Title: Meeting of NRC and Pennsylvania
Power & Light on Fuel Pool Cooling

LOCATION: Rockville, Maryland

DATE: Thursday, July 8, 1993

MEETING OF NRC AND PENNSYLVANIA POWER & LIGHT
ON SPENT FUEL POOL COOLING

Typical Refuel Outage - Time To Boil

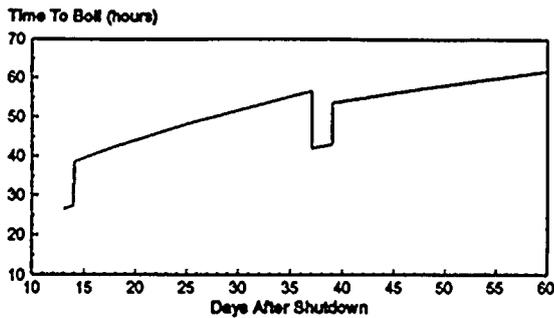
19 MR. SHUM: In this slide, you indicate that the
20 accumulation is 250Ks, but in your previous submittal, in
21 response to our questions, you show about twice as much,
22 more than twice as much. Why is there that much difference?

23 Here they show 250Ks. In their previous
24 submittal, on page 22, there they show -- the calculations
25 show that the accumulation would be 800,000 gallons.

9 MR. MILLER: This is the volume commensurate with
10 the actual plant configuration, the isolated pool after an
11 outage.

12 The only way you could get the other number -- we
13 were doing that at that point to provide a bounding
14 condition -- would be to do your offload and isolate the
15 pool right away, which is something that we don't do.
